**A RESOLUTION OF THE CITY COUNCIL OF SUNNYSIDE,
WASHINGTON, ADOPTING THE PLANNING COMMISSION'S
RECOMMENDATION AND APPROVING THE PRELIMINARY
PLAT OF FAIRVIEW HEIGHTS**

**SUNNYSIDE PLANNING COMMISSION
RECOMMENDATION TO THE SUNNYSIDE CITY COUNCIL
PRELIMINARY PLAT OF FAIRVIEW HEIGHTS
PLP-25-1, SEPA-25-2**

**CITY OF SUNNYSIDE
PRELIMINARY LONG PLAT RECOMMENDATION**

DATE: August 12, 2025
TO: Applicant, Adjoining Property Owners
FROM: City of Sunnyside
APPLICANT: Chinook Venture Rentals, LLC c/o Emmanuel Ramos
FILE NUMBER: PLP-25-1, SEPA-25-2
LOCATION: Vicinity of Fairview Ave and N 6th St
TAX PARCEL NUMBER(S): 221024-31406
APPLICATION DATE: January 26, 2025
DATE OF COMPLETENESS: May 8, 2025
RECOMMENDATION: APPROVE WITH CONDITIONS

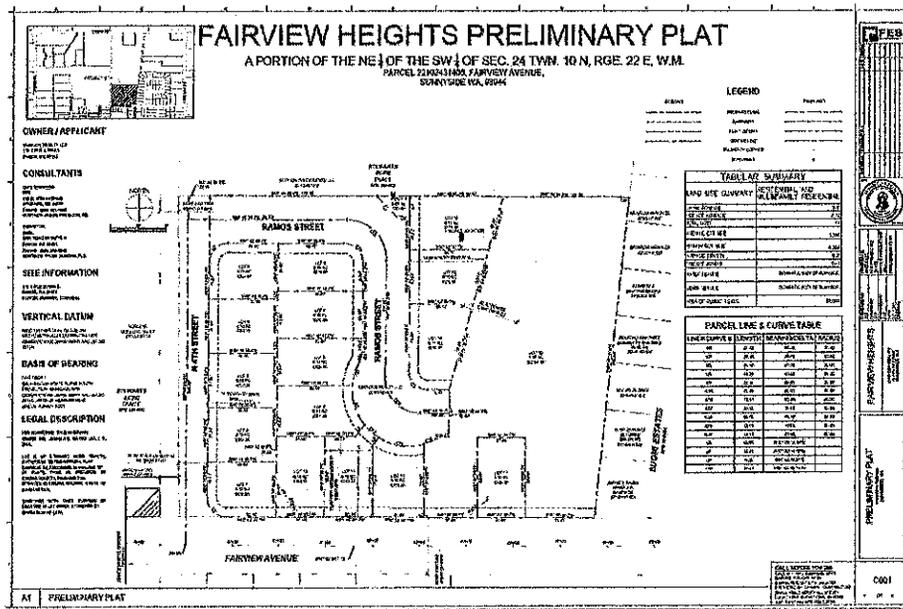
1. The proposed right-of-way of 50-feet for N. 4th Street and Ramos Street may not be adequate for the roadway, curb and gutter, sidewalks, lighting, and stormwater system. A roadway cross section was not provided for review.

2. The connection to Ramos Street must meet International Fire Code turnaround requirements. The Preliminary Plat Map shall be revised to include a cul-de-sac consistent with the Design and Construction Standards and the International Fire Code, Appendix D, Section D103. Requirement is consistent with Sunnyside Municipal Code 16.32.070.6.

3. Applicant shall revise the Preliminary Plat Map as necessary to meet the International Fire Code Section D105. The City of Sunnyside utilizes Aerial Fire Apparatus and considering the new cul-de-sac's location will be within a power easement, Section D105, and Section D105.4 Obstructions will apply to this development.

4. Applicant is required to meet Section D107 of the International Fire Code. If duplex units are proposed on lots 1-17, or the total number of one -- or two-family dwelling units exceed 30 then two separate fire apparatus access routes shall be provided from Fairview Avenue. If multiple Fire Apparatus routes are required then they shall be connected.

5. There is no apparent use for the proposed 15-foot Fire & Access Utility Easement proposed to overlap Lot 11. This easement does not meet the requirements for fire access.

6. Identify use of Tract A. Provide information on the ownership and maintenance of Tract A on the Preliminary Plat Map.
7. Applicant shall identify a roadway section for the new roadways. If stormwater swales are intended to manage stormwater for Ramos Street and N 4th Street, then the swales must be located within the Public Right of Way. The minimum 50-foot right of way width may not be appropriate.

8. All lots shall access from either N. 4th Street or Ramos Street.
9. Access for Lot 17 shall be from Ramos Street. The Preliminary Plat Map shall be revised to show access for Lot 17 from Ramos Street.

10. The access for Lot 10 shall be clarified and revised on the Preliminary Plat Map. Lot 10 shall access from the new cul-de-sac on Ramos Street.
11. Lot 11 shall access from the new cul-de-sac on Ramos Street. Revise Preliminary Plat Map to clearly show access. If an access easement is required for Lot 10, identify easement location on the Preliminary Plat Map.

16. A 10-foot Utility Easement is shown between lots 16 and 15. Applicant to identify easement type. Minimum City utility easement width is 16-feet. If sewer and water shall be located within the same easement, the utilities must meet Department of Health separation standards and the utility must be centered within the easement. For joint sewer and domestic water easements the minimum easement width is larger and depends on the utility layout.

17. A 10-foot Utility Easement is shown between lots 2 and 3. Applicant to identify easement type. Minimum City utility easement width is 16-feet. If sewer and water shall be located within the same easement, the utilities must meet Department of Health separation standards and the utility must be centered within the easement. For joint sewer and domestic water easements the minimum easement width is larger and depends on the utility layout.

20. The Utility Plan provided is not drawn at the scale indicated on the plan sheet and consequently general conformity with the adopted standards cannot be determined. Revise and resubmit the utility plan for review.

21. A significant amount of information is missing from the Preliminary Plat Map and consequently all development requirements cannot be provided until additional information is provided by the Applicant.

5. The proposed 15-foot Fire and Access Utility Easement serving Lots 10 and 11 does not meet the minimum IFC standard (20-feet).
6. All stormwater shall be retained on-site. The applicant shall submit plans for city approval, consistent with the Department of Ecology Stormwater Management Manual for Eastern WA.

11. The Preliminary Plat Map shall be revised to show the following:
 - a. A note describing the use and purpose of Tract A – including ownership and/or maintenance responsibilities.
